CARLO GAVAZZI SPACE SpA		0 CERN MIT L3 A&C/AMS AMS02-PDS			1 Doc.N°: NCR-PDS-CGS-C-128 Rev.: 1 Date: 18/12/2008 Page 1 of 2 attach: A,B,C,D,E	
		NON CONFORMANCE REPORT				
2 NCR Title: CAN BUS 01/02 CPU_RST command						
IDENTIFICATION	3 Supplier	4 Purchase Order N°	5 Model	6 Subsystem	7 Procedure/Work Item N°	
	CGS	N.A.	PFM	N.A.	N.A.	
	8 NC ITEM Identification	9 Drawing N°	10 Rev.	11 P.N. / C.I. N°	12 Serial N°	
	Can Bus I/F Board Assy	11-AMS02PDS-500.00	/	11-AMS02PDS-500.00	01 / 02	
	12 Next Higher Unit Id.	13 Drawing N°	14 Rev.	15 P.N. / C.I. N°	16 Serial N°	
	AMS02 Power Distribution System Assembly	10-AMS02PDS-000.00	/	10-AMS02 PDS - 000.00 POS 18	FM01	
DESCRIPTION	18 NON CONFORMANCE Detected During:					
	RECEIVING INSP. <input type="checkbox"/> MANUFACT. <input type="checkbox"/> ASSEMBLY/INTEGRATION <input type="checkbox"/> FINAL INSPECTION <input type="checkbox"/> TEST <input checked="" type="checkbox"/> OTHER <input type="checkbox"/>

MINOR <input checked="" type="checkbox"/> MAJOR <input checked="" type="checkbox"/> Corrective/Preventive Actions: NONE					
	24 REQUEST FOR WAIVER 20/01/09					
	YES <input type="checkbox"/> NO <input checked="" type="checkbox"/> N° Analysis

Fig. 2: CAN 30 input lines during "CPU_RST" command on can 31.

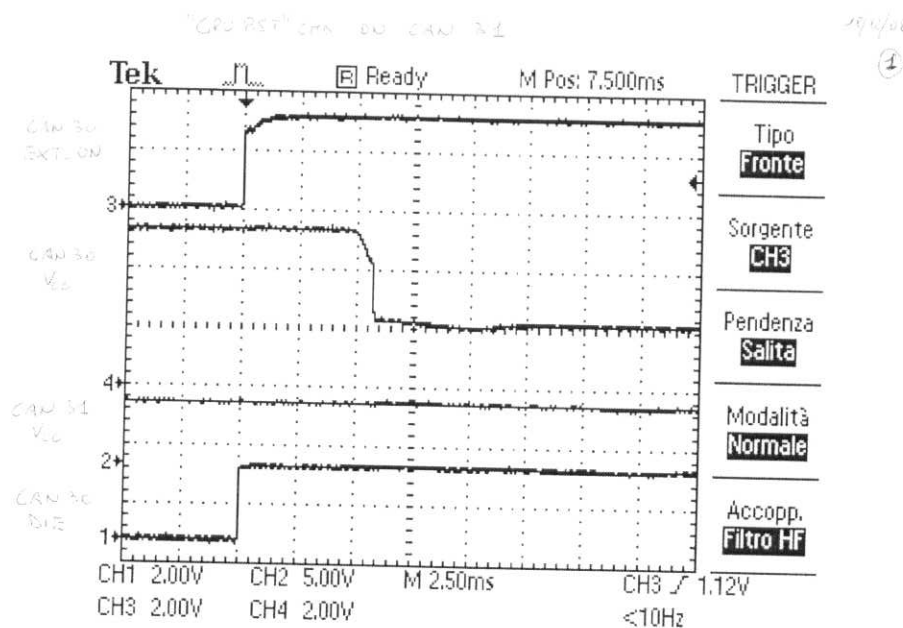
Pressing the button "CPU_RST" the CAN 31 micro set the pin S_ON and the pin S_OFF (connected to relative circuit on Can 30) to high value at the same time. This correspond to found the can 30 board SWITCHED OFF.

Fig 2 shows the rising of the command lines and fig.3 shows the sw reading. After this command the CAN 31 remain in the previous condition while the CAN 30 results in OFF status.

New sw has been loaded and tested on both CAN BUS FM board S/N 01 and 02 successfully.
Pressing the CPU RST button on the software test the anomaly has not been reproduced anymore.
The lines S_ON and S_OFF are not commanded in high state.
The CPU RST button issue is considered solved.

Fig. 4: S_ON command from 31 to 30 after "CPURST" command

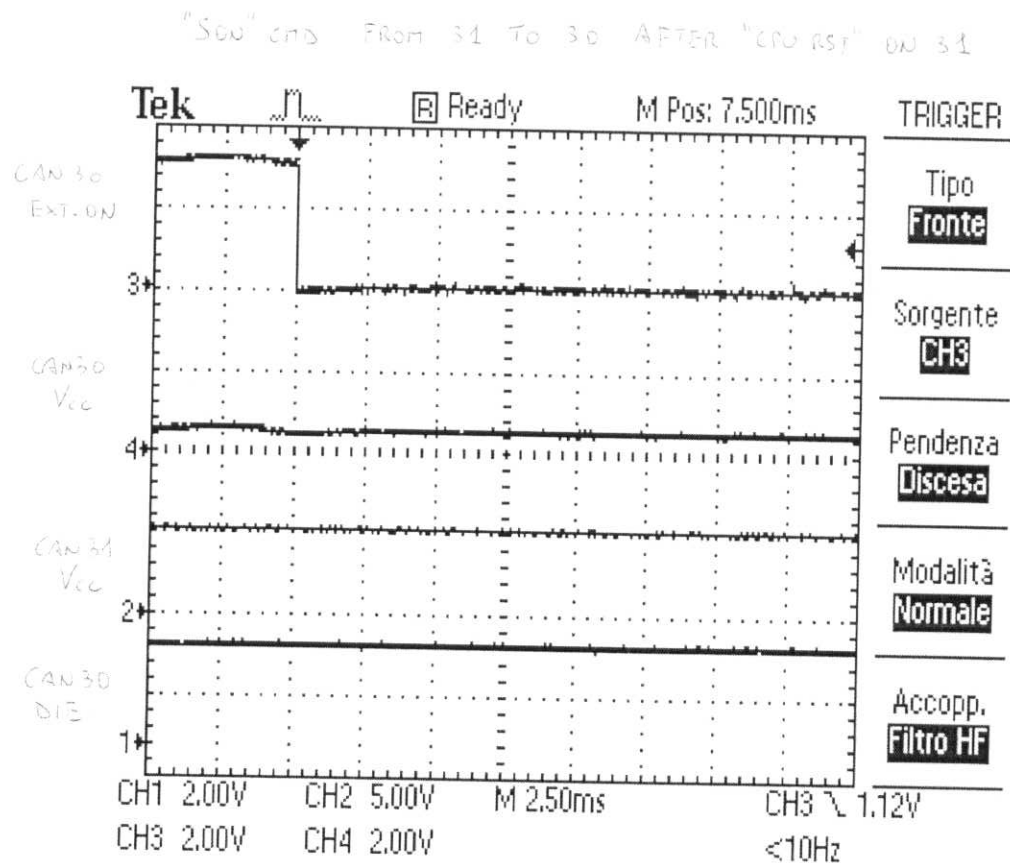
Sending the S_ON the can 30 remains in OFF condition. The micro output line is now reset and come back to correct ZERO value as fig.4 shows.

Fig. 5: S_ON command from 31 to 30 second try

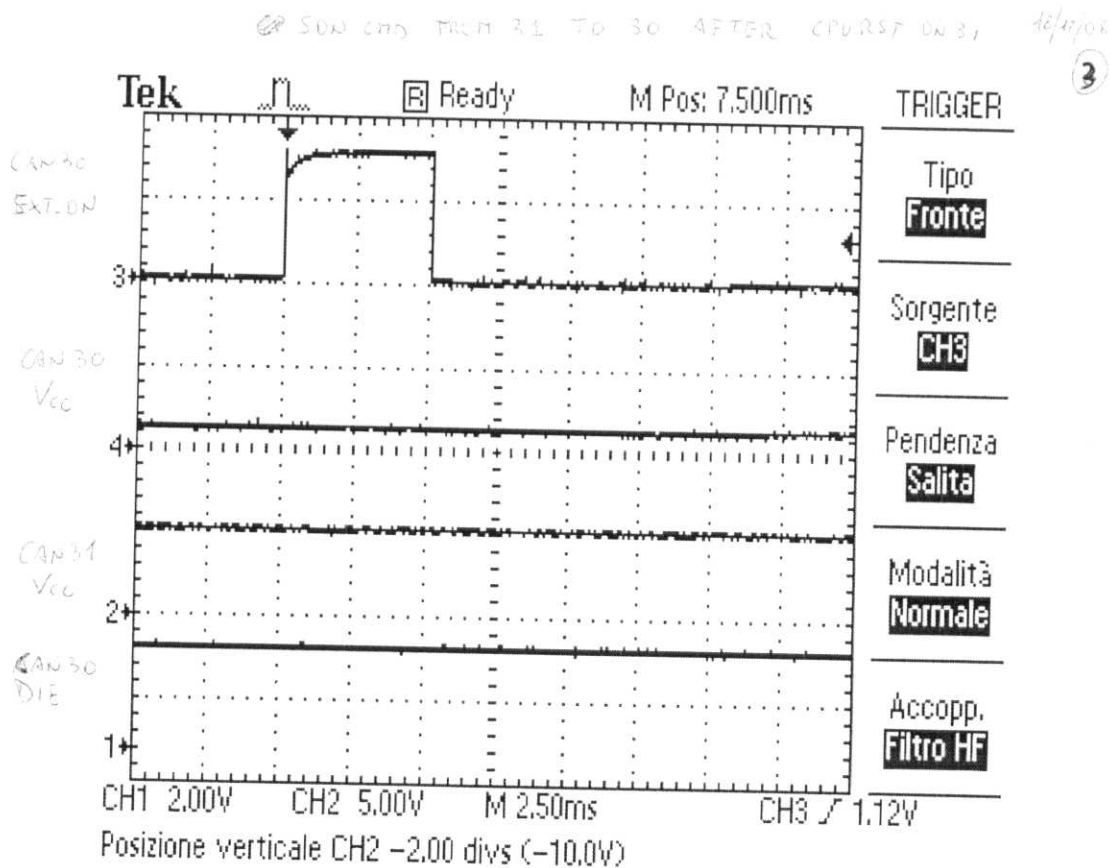
A second S_ON command has been sent to verify if can 30 comes back alive. But due to the presence of the high state of the DIE line the board does not restart. Fig.5 shows this situation.

Fig. 6: S_OFF command from 31 to 30.

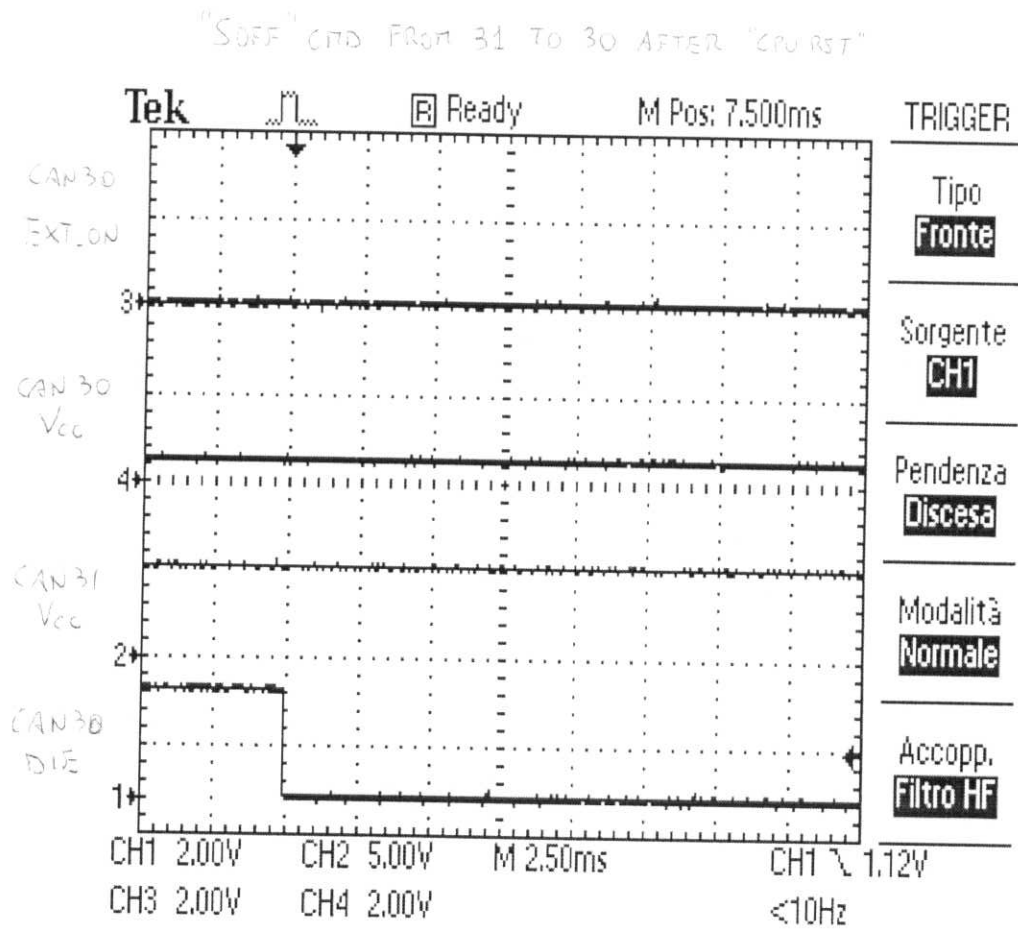
The S_OFF command has been sent to reset the die line on can 30. fig.6 shows the line transition.

Fig. 7: S_ON command from 31 to 30 after resetting the command lines.

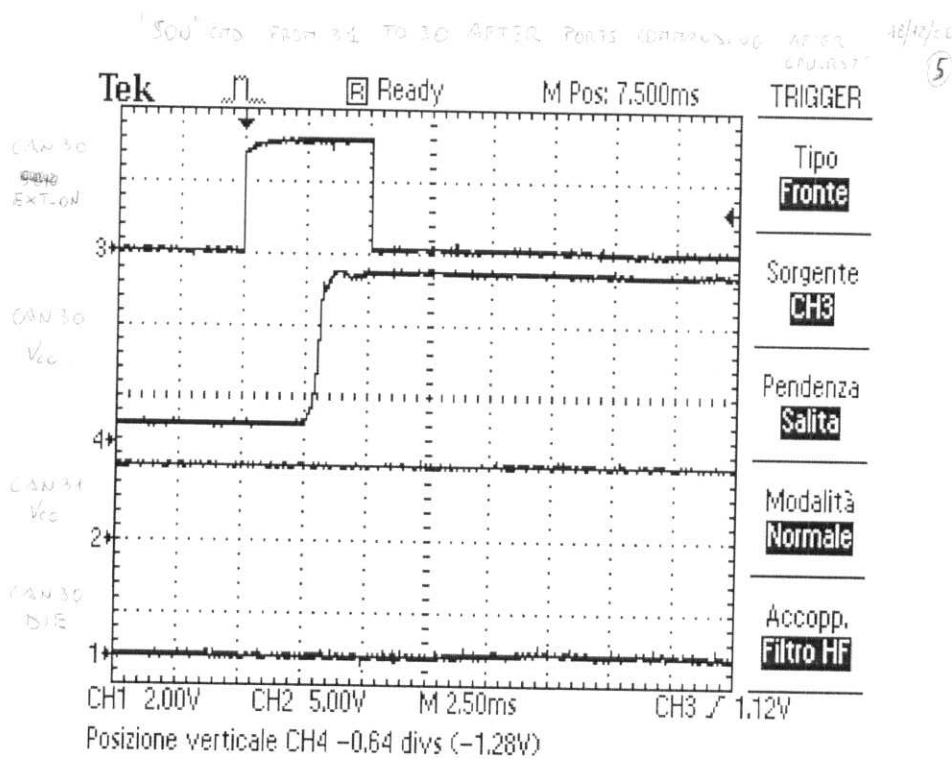
At this point an S_ON command has been sent again to verify if can 30 comes back alive. At this time the board restarts. Fig. 7 shows line transitions while fig.8 show the sw reading.
